ALLEN DATAGRAPH

Technical Support Bulletin: Field Adjustment For 536 Motors Too Hot

Applicability: This change required for all 536 and i-TECH 536 Rubber cutters manufactured prior to 4-22-5. Serial numbers I504517 and less and all serial numbers starting with letter "P".

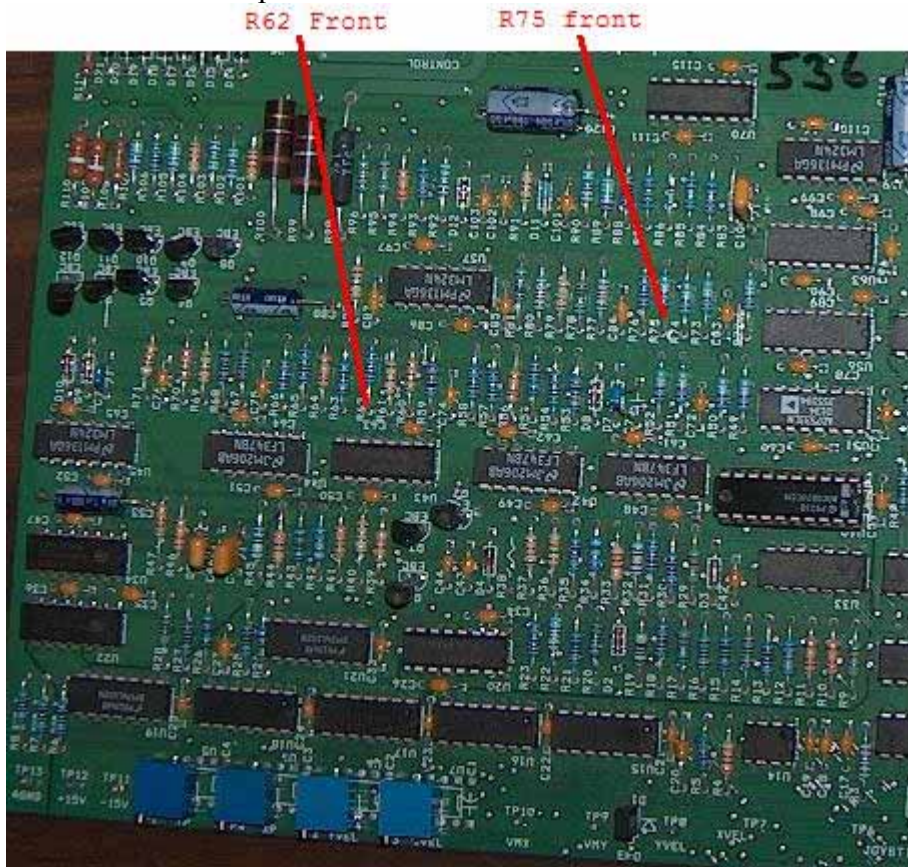
24 button 3 digit display machine instructions: Press function 3, 1, 7, enter, wait for 0 to appear. Press 3 button. The value 300 will be displayed for a short period. Grit wheel motor will start to run and the speed the grit wheel is turning is displayed in the 3-digit display. Adjust the speed of the grit roller with the xp pot turning screw counter clockwise to slow down speed and clockwise to increase speed until display reads 242.
